**COUNTY OF SAN MATEO
PLANNING AND BUILDING DEPARTMENT**

SUBJECT: Consideration of a Coastal Development Permit, Non-conforming Use Permit, and Design Review Permit, pursuant to Sections 6328.4, 6133.b, and 6565.3, respectively, of the San Mateo County Zoning Regulations; and a Certificate of Compliance (Type B), pursuant to Section 7134 of the County Subdivision Regulations (January 1992), to legalize an undeveloped substandard-sized 2,285 sq. ft. parcel on Vassar Avenue; and to allow the operation of a beach club facility for Coastside Beach Club members, located in the unincorporated Princeton area of San Mateo County. The Non-conforming Use Permit includes an off-street parking exception to waive the required three (3) off-street parking spaces. The project is appealable to the California Coastal Commission.

County File Number: PLN 2017-00485 (Dragony)

OVERVIEW SITE PLAN

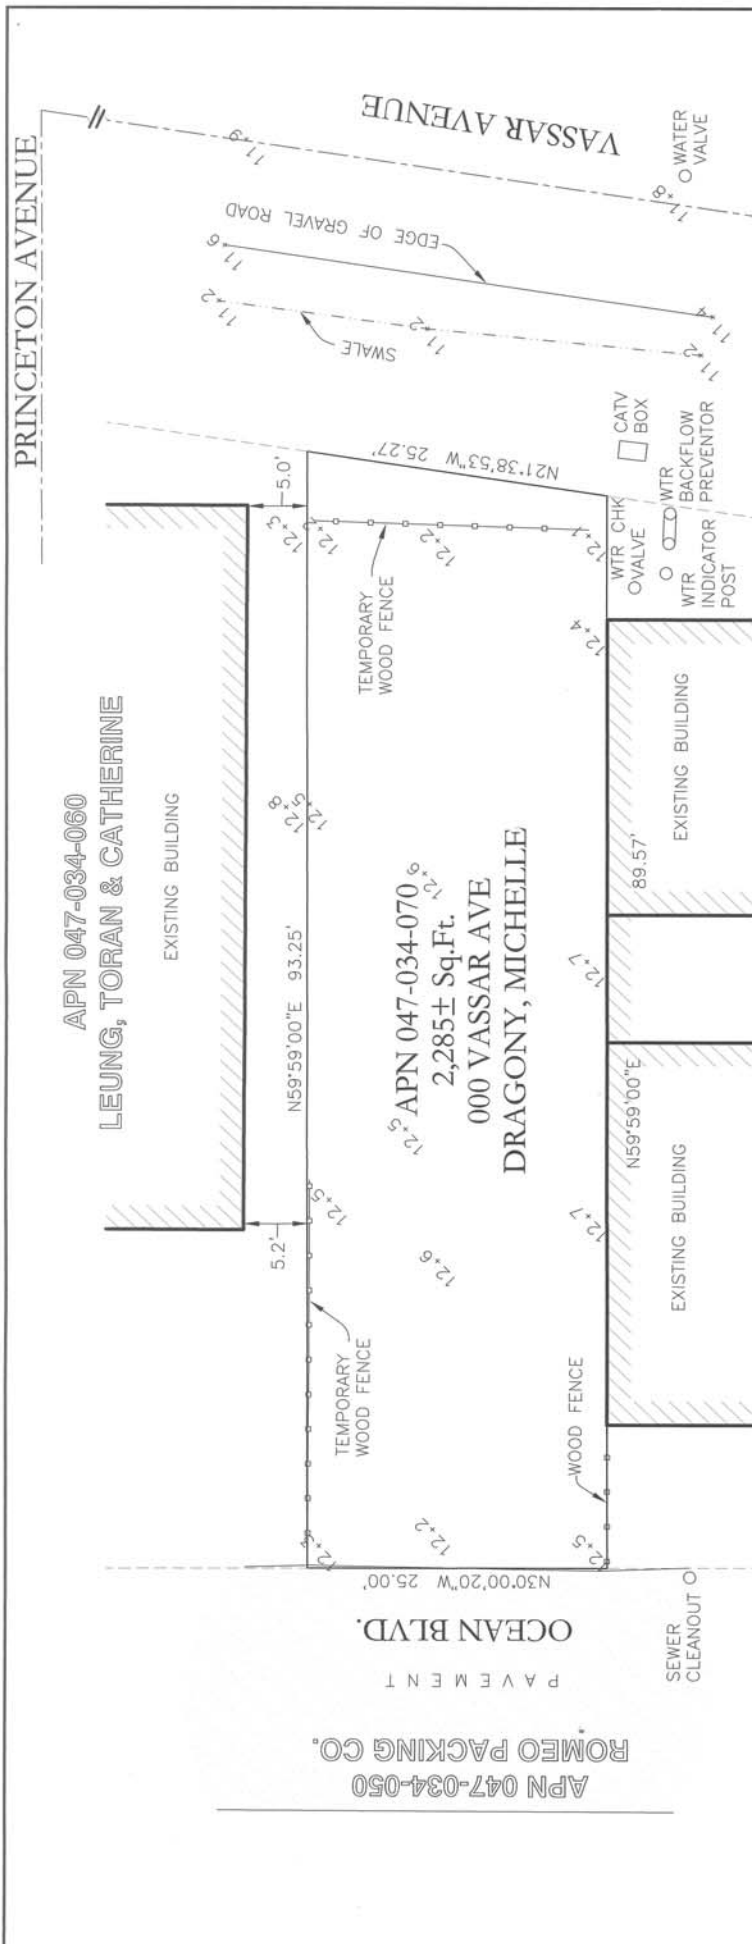
Comment 1: need to have survey revised and submit a new signed and sealed copy

Comment 3: provide response or revision if you can, maybe you can do sand with some designated areas in grass or other natural material to keep the sand on-site? Otherwise, based on DPW's concerns with carpeting, we will probably be looking to recommend a condition on the project that specifies that carpeting is not going to be allowed (if this is the case, then at the hearing you would have the opportunity to try to persuade the decision maker otherwise)

Comment 4: need to provide a drainage plan - wash down, clean up, storage sheds, etc. needs something to protect the neighboring property's foundations.

Comment 7: need to provide a drainage plan

Comment 1: See sign picture. It is labeled as Ocean Blvd. Clarification would be achieved if you attach the picture and write in "Private Road" on the survey.. Or you can change the signs, and then I'll pay the survey to ad "private road". You are correct that the road is own by Romeo. It is identified clearly as "Ocean Blvd Easement" on my plans which makes it clear it is not a public road.

Comment 3: The carpet has been in use for close to two years. There is no mold or mildew. Mold and mildew do not grow in well ventilated areas and this are is windy. It is also to the UV of full sun. Carpet under these conditions works. It holds weeds down passive, without Roundup or gas exhaust of a wacker. DPW can inspect for themselves.

Comment 4: It takes a couple of gallons to rinse a kayak. 10 members and they paddle twice a week tops. 40 gallons spread out over a week. No water has every run off as the carpet is a perfect water detention tool. DPW is welcome come paddle and I can demonstrate the wash off.

Comment 7: Again, the carpet detains the the water as it runs off. Come by during a rain.
